WARRANTY
CAMPAIGN

Campaign no.: 2010-0003

December 18th, 2009 Subject: **Spyder™ RT Electronic Modules Software Update**

REVISION 1
January 14, 2010

LCD Software Validation

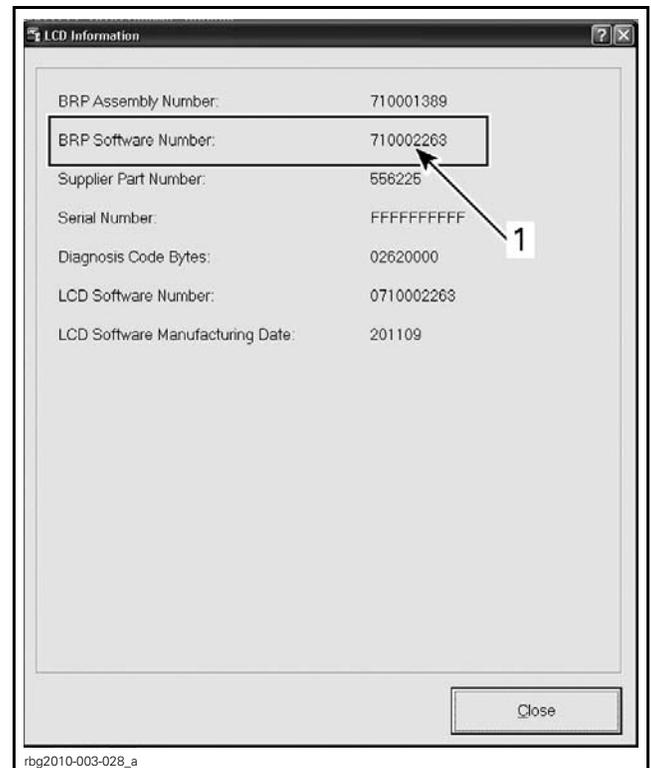
➡ ~~710002208~~ 710002263 ⬅
